# *RVON-I/O*

## *Release*

## *Notes*

**The RVON-I/O card once these changes take place will go from 9030-7772-000 Rev A to 9030-7772-000 Rev B.**

FIGURE 1. Crosstalk Resistors to Capacitors placement (board number 9030-7772-000).

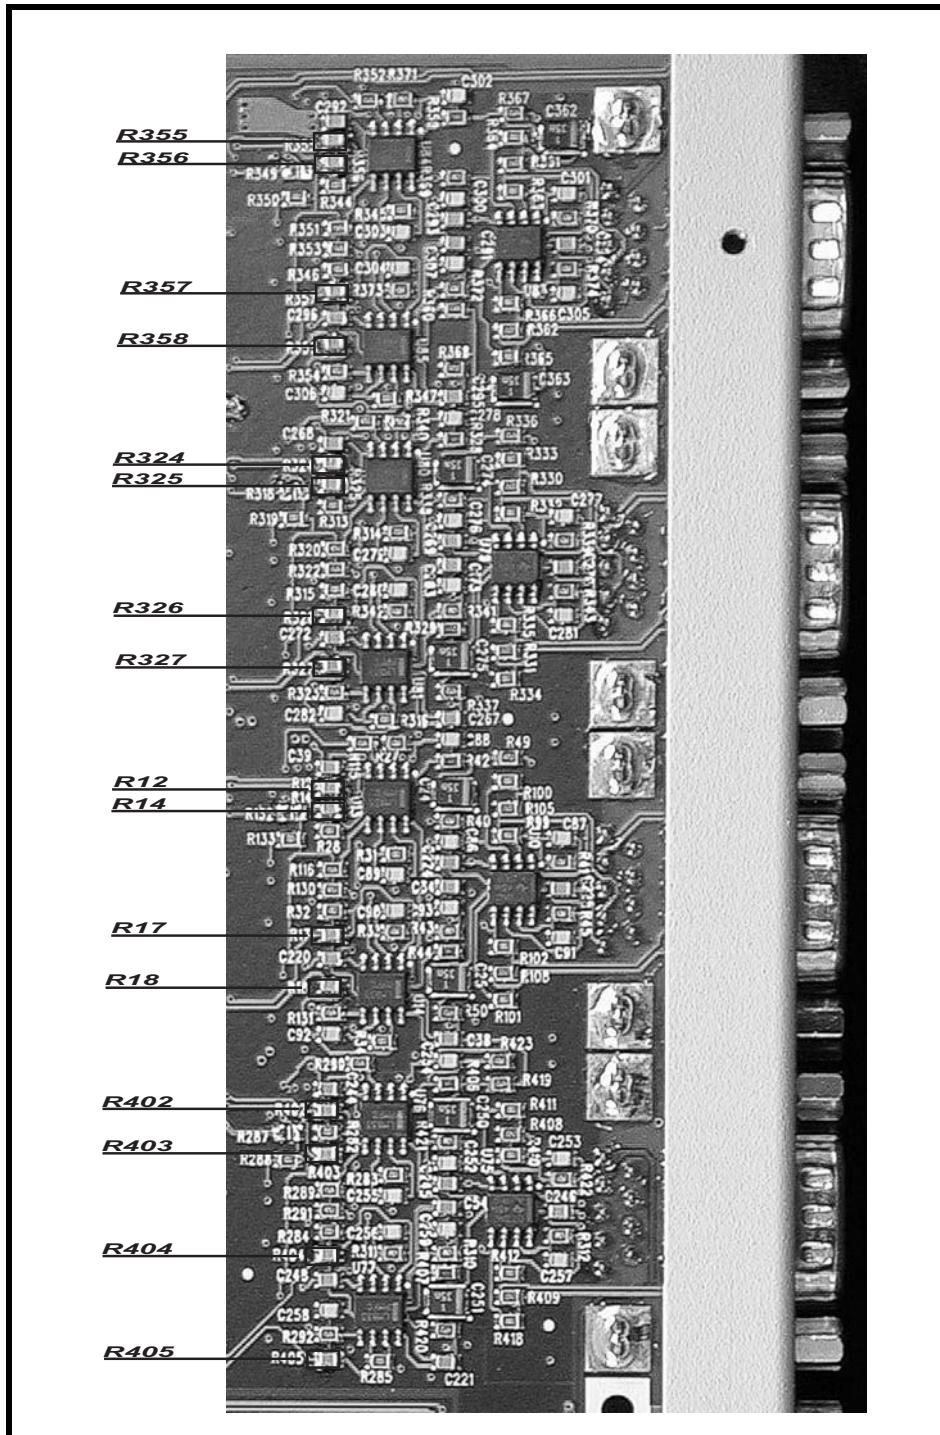
The output to the matrix is being heard on the same channel's input. The input to the Codec need to be AC coupled. To fix the crosstalk on the same channel, you must remove 16 resistors (150Ohm) - **R12, R14, R17, R18, R324 - R327, R355 - R358, R402 - R405** and replace with 16 capacitors (part number **102881-880**, 0.47 uF 16V) in **R12, R14, R17, R18, R324 - R327, R355 - R358, R402 - R405**. For replacement positions, see figure 1.

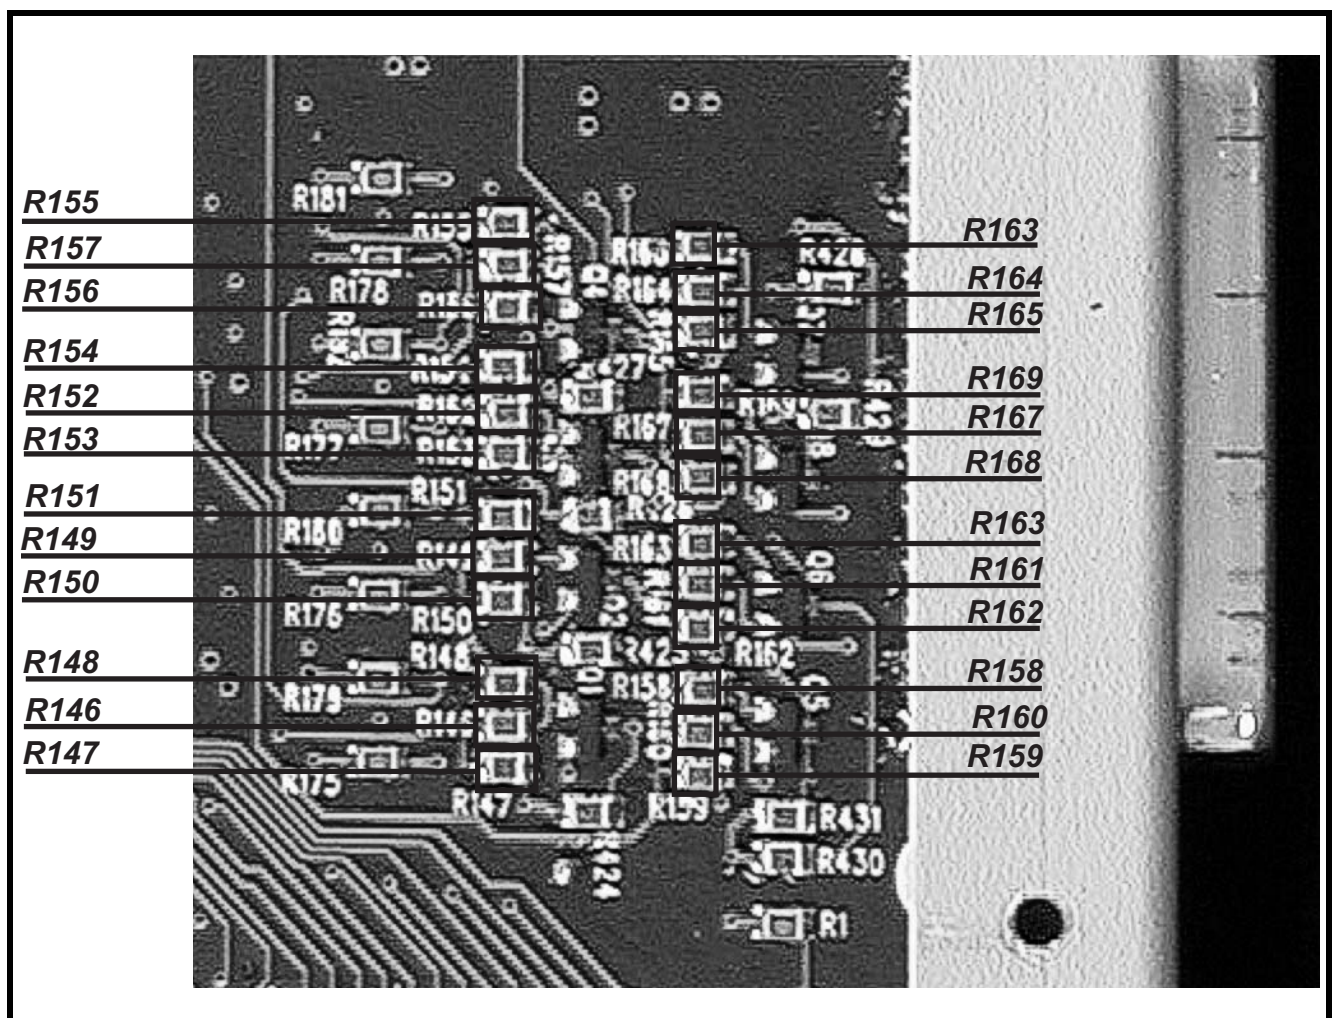
The GPO transistor can't handle the current load for a dual Master Controller chassis. The GPO transistor's input resistors need to be reduced to increase the base current. This will increase the collector current's load.

To fix this issue, change the 3 input resistors of each GPO from 22.1K to 2K. This increases the collector current from ~10 mA to ~60 mA. The transistor can handle 200 mA.

Also, remove 24 resistors, **R146 through R169** and replace them with 2K resistors (part number **102515-229**). See figure 2 for resistor placement.

FIGURE 3. Resistor Changes

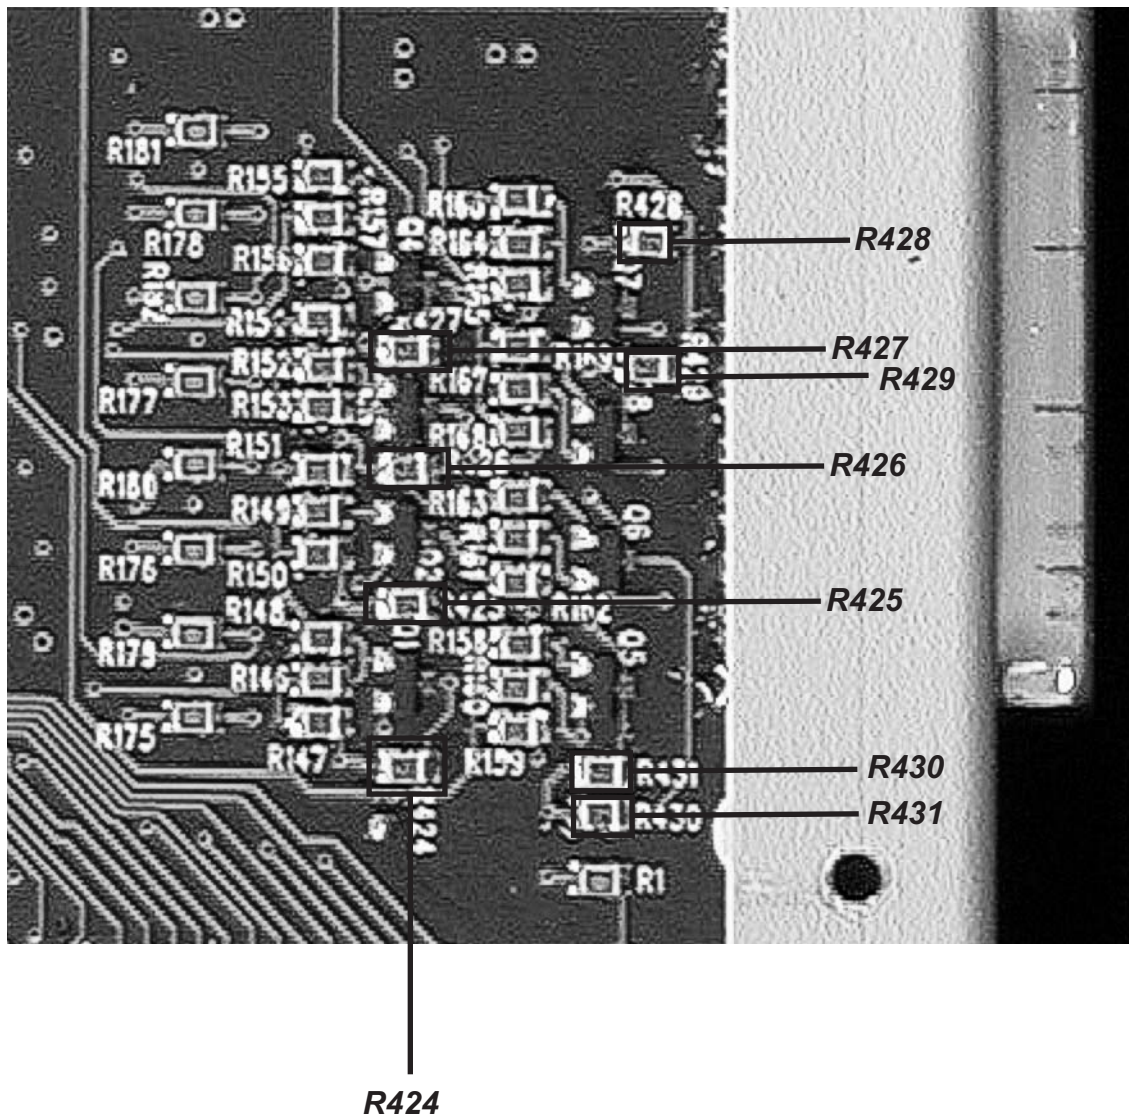
The RVON-I/O's voltage drop across the GPO output resistor is too large for the Cronus photo coupler GPI. The Cronus series resistor to the photo-coupler is also too large. The voltage drops across both resistors prohibit operation.

To fix this issue, change the RVON-I/O GPO Output from 22.1K to 6.19 K on the RVON-I/O card and replace four resistors (R11 through R14) from 3 K to 470 Ohms.

1. On the RVON-I/O card, remove 8 resistors (**R424 through R431**) and replace with 6.19 K resistors (part number **102515-276**). See figure 3 for resistor placement.

**FIGURE 4. Cronus board resistor placement.** The Cronus Master Controller board will go from 9030-7788-001 Rev A to 9030-7788-001 Rev B

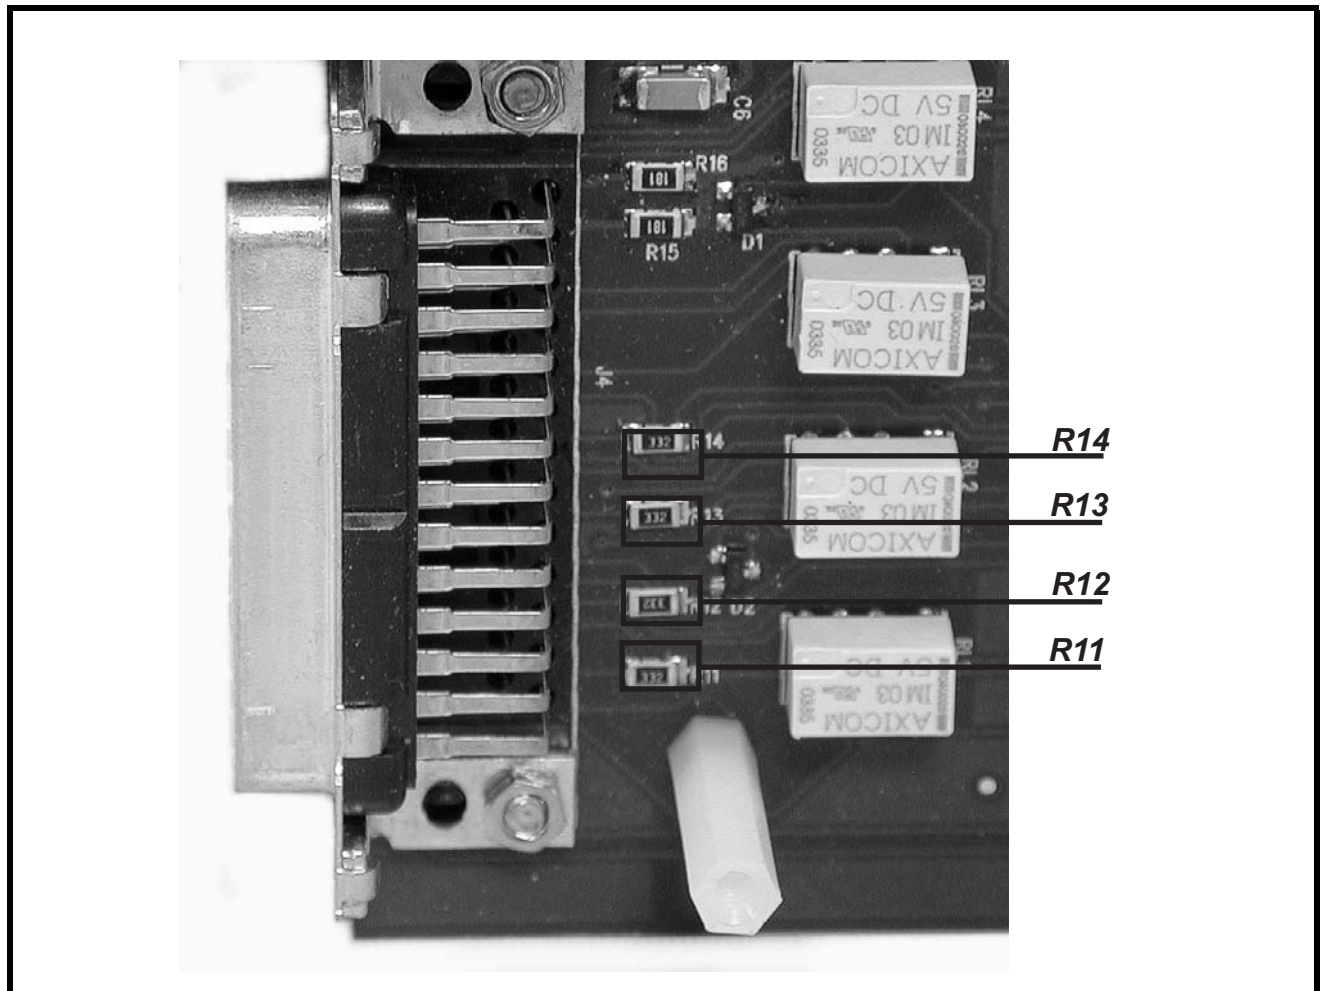
2. On the Cronus MC Back card, remove the 3K resistors (**R11 through R14**).
3. Replace with 470 Ohm resistors (part number **102513-471**).
